Attached please find ten copies of the report on the generic evaluation of the Significant Deficiency identified in the design of the attachment of the Control Rod Drive AC Breaker Cabinets to the floor for seismic excitation loadings. This deficiency has been reported to the affected utilities and remedial action has been initiated through field change packages. The attachment modifications described in the report are being factored into the design for later plants.

Report on CRDCS Breaker Cabinet Seismic Qualification

This report, pursuant to 10 CFR 50.53(e) on Significant Deficiencies, is to document the investigation of the significant deficiency in the seismic qualification on the Control Rod Drive Control System Trip Breaker Cabinets.

AC BREAKER CABINET
ATTACHMENT MODIFICATION

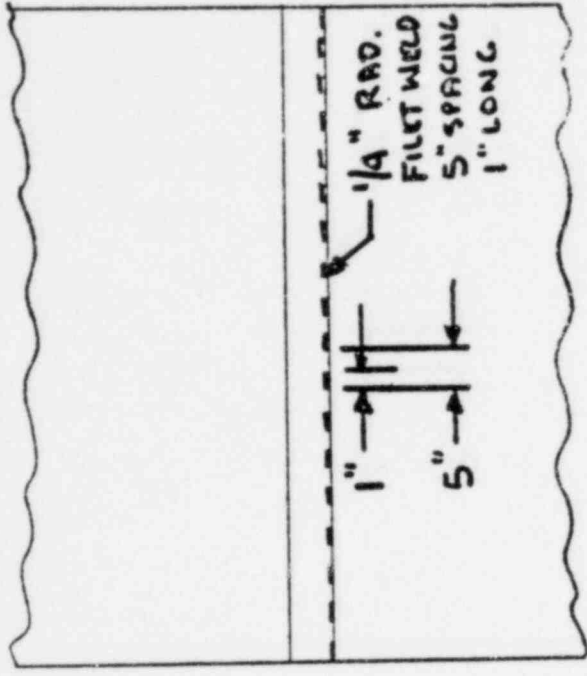
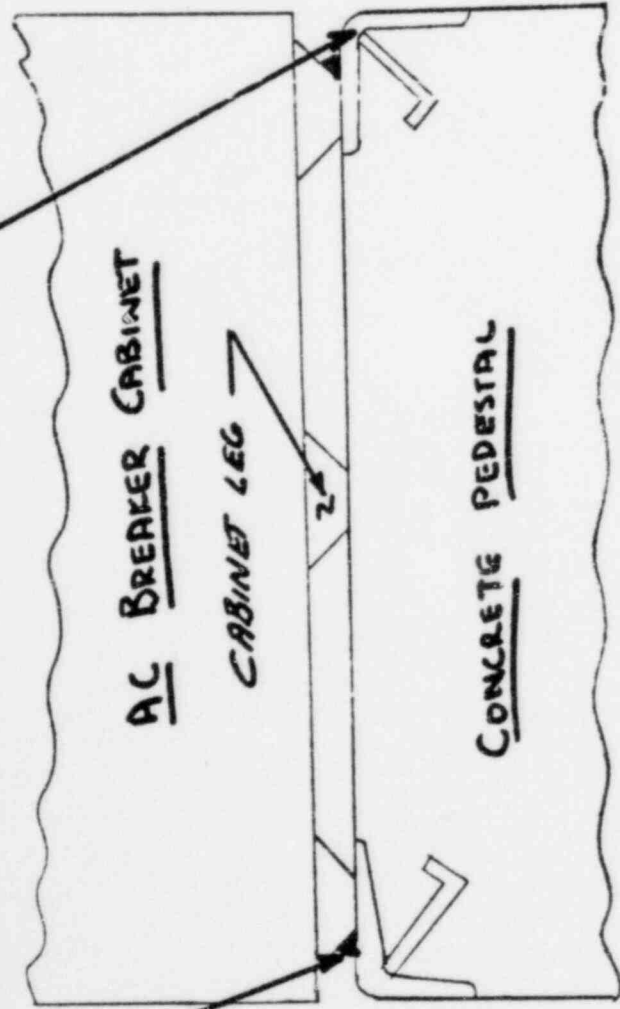
A reevaluation of the seismic qualification of the control rod drive control system AC breaker cabinets has found that the recommended attachment of the cabinet to the floor is inadequate to withstand the SSE acceleration levels.

In the event of an SSE, the AC Breaker Cabinets could, as per the finite element stress analysis, break loose from the floor mounting. With the cabinets unattached, the random motion or even falling over could cause accelerations of the breakers that have not been analyzed or damage to the breakers, wiring, or connections which could compromise the ability of the breakers to trip the control rods. Analyses cannot show that the failure will always be fail safe. Therefore, the deficiency in the design of the structural attachment of the AC Breakers Cabinets to the floor could adversely affect safety. This problem is thus considered to be a Significant Deficiency as per 10 CFR 50.55 (e).

The attachment of the AC Breaker Cabinet to the floor has been redesigned (see attached figure). Depending upon the arrangement at the particular site, either additional bolts will be included or a series fillet welds will be added to increase the attachment strength. Each plant with a construction permit or operating license is being evaluated on an individual basis. Newer plants are employing cabinet holddown designs which will assure the ability to withstand SSE loadings.
